# UNITED STATES PATENT AND TRADEMARK OFFICE

APPLICATION NO.	FILING DATE	FIRST NAMED INVENTOR	ATTORNEY DOCKET NO.	CONFIRMATION NO.
10/693,324	10/24/2003	Neal H. Domgaard	T10219	8243

## Office Action Summary

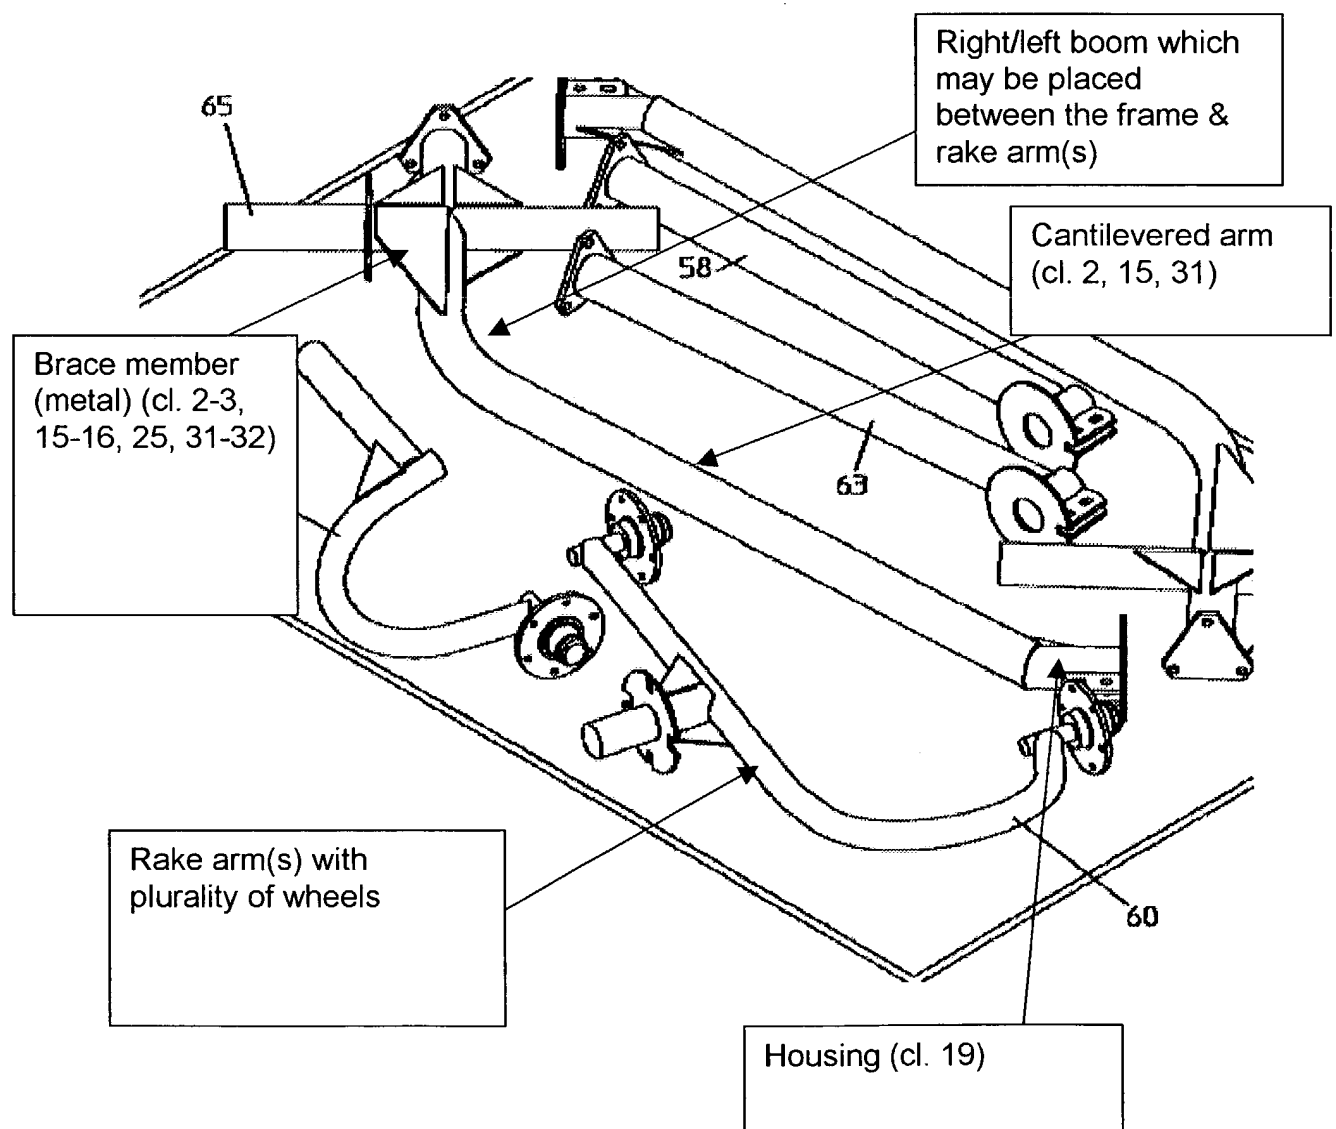
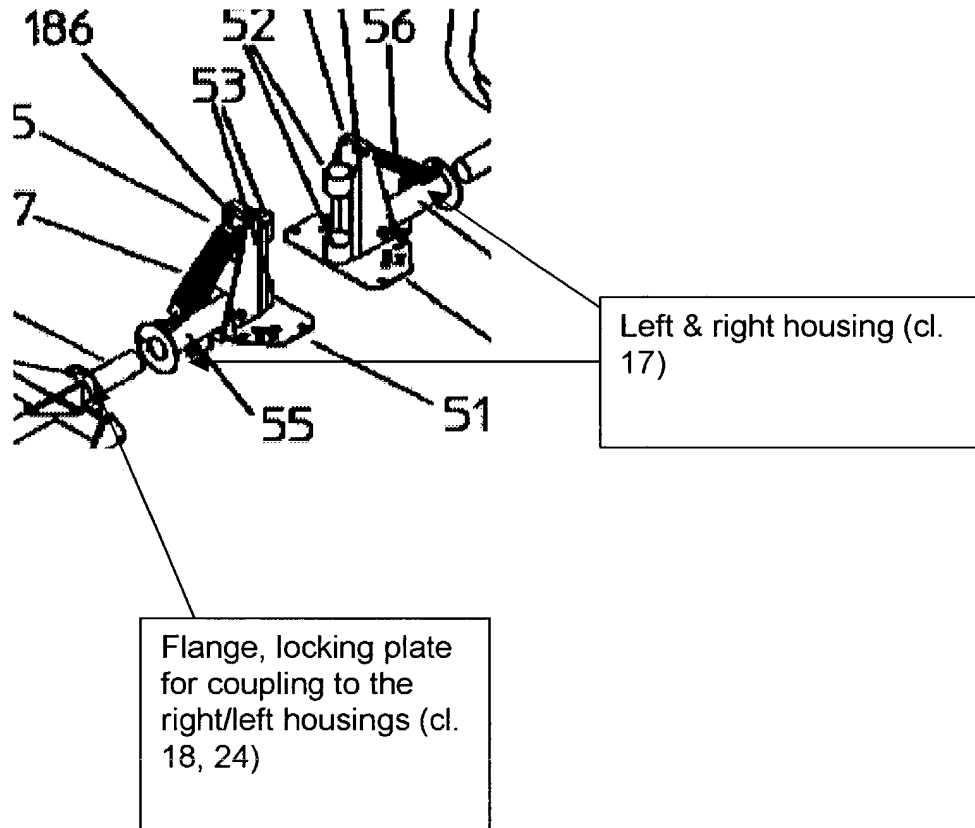
6. Claims 1-3, 14-20, 30-32, 36-42 are rejected under 35 U.S.C. 102(b) as being anticipated by Menichetti et al (6000207).

Menichetti discloses and as shown bellow:

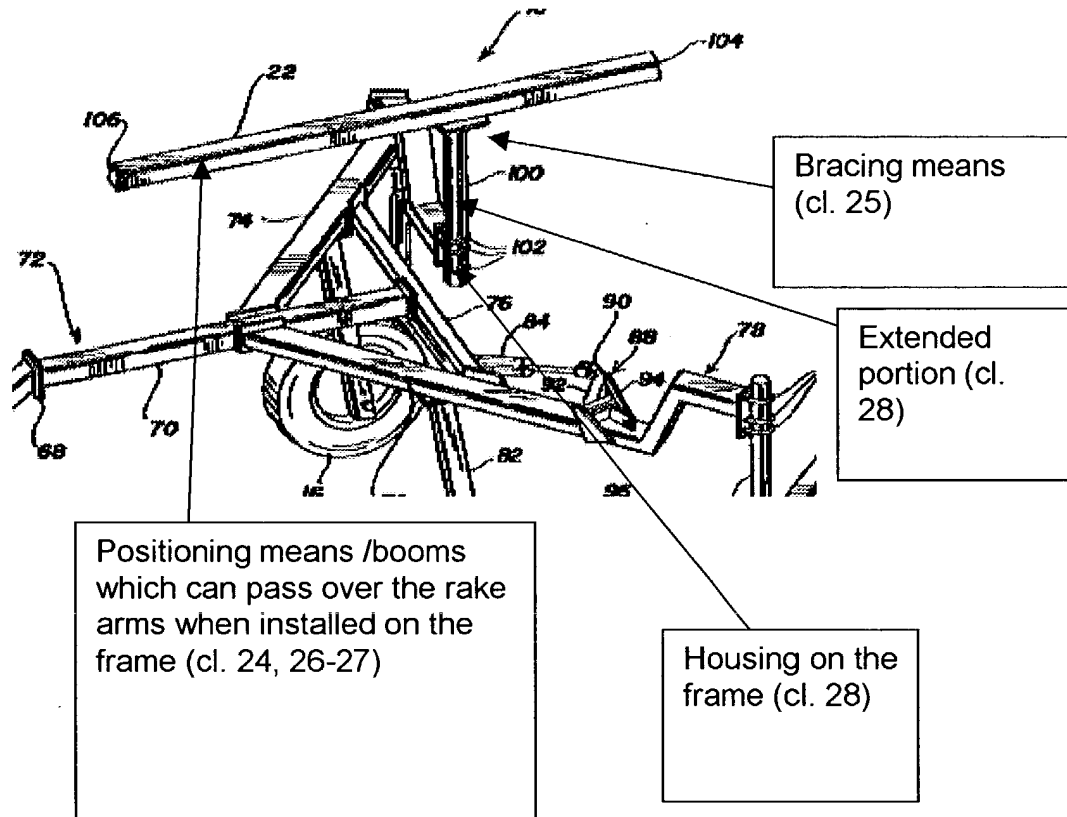
8. Claims 24-29 are rejected under 35 U.S.C. 102(b) as being anticipated by Wright et al (5956934).

Wright discloses and as shown bellow:
